2021-08-11

Purpose for Service Bulletin

Figure 1. Bracket Part No. 76000856A

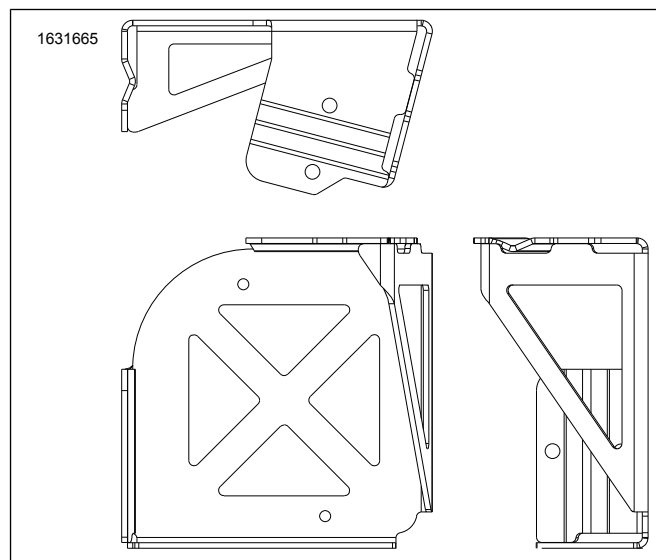
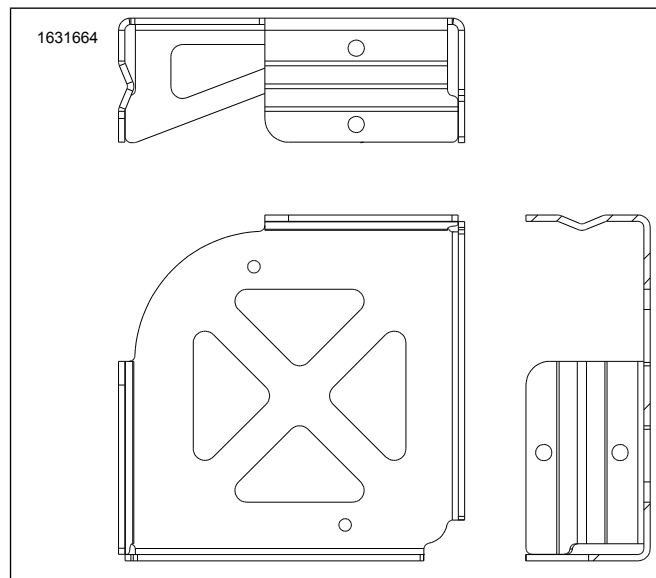
- See Figure 1. If dealer has inventory of bracket Part No. 76000856A, no action is required.
- See Figure 2. If dealer has inventory of bracket Part No. 76000856, remove part from inventory. File a Defective Stock (DFS) warranty claim. Refer to Table 3.
- If dealer has inventory of Audio Kit (76001039), check kit. If kit has bracket Part No. 76000856A, no action is required. If kit has bracket Part No. 76000856, remove part from kit. File a Defective Stock (DFS) warranty claim. Refer to Table 3. Order replacement bracket (Part No. 76000856A) using the standard part ordering process and replace kit with new bracket.
- If motorcycle has obsolete bracket installed, remove and replace with new bracket. Submit warranty claim. Refer to Table 2.
- If front fender is damaged, receive authorization to remove and replace damaged fender.
